Case File / Name: S-53-14 / 5401 North Lot 20

Nature of Case: The further subdivision of Lot 10 from S-24-12 within MP-1-10, 5401 North

SUBJECT: S-53-14 / 5401 North Lot 20

OFFICIAL ACTION: Approval with conditions

Subdivision Plan

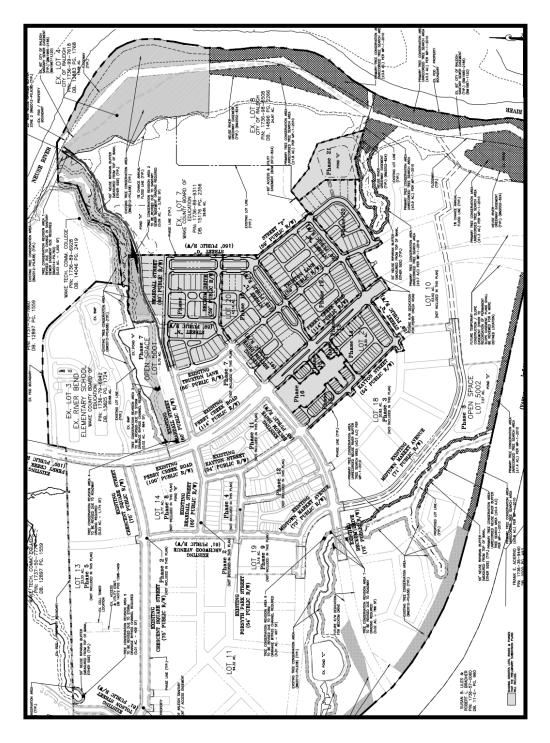
- (5) That the streetscape on both sides of Perry Creek Road is shown as an 11' sidewalk from curb to back of sidewalk with 4 x 6 tree grates;
- (6) That revised construction plans for S-18-14 are approved to reflect the correct streetscape plan. On the west side of Perry Creek Road, an 11' sidewalk is to be shown, including tree grates due to the proposed uses along the West side of Perry Creek being residential. The east side of Perry

- Creek shall remain in accordance with MP-1-10, a 15' sidewalk with tree grates.
- (7) That a stormwater control plan with a stormwater operations and maintenance manual and budget shall be approved by the Stormwater Engineer in compliance with Part 10A Chapter 9 of the Unified Development Ordinance, including the designation of buffer areas and open space areas for stormwater purposes prior to grading or the approval of construction drawings whichever event comes first;

Ordinance with MP-1-10. This information can be found in the Master Plan file, MP-1-10. Perry Creek Road on both sides, will have 11' sidewalk with 4' x 6' tree grates. The east side of Street O will have 8' sidewalk with trees installed in 4' x 6' tree grates. All other streets will have 5' sidewalk with 7.5' planting strip.
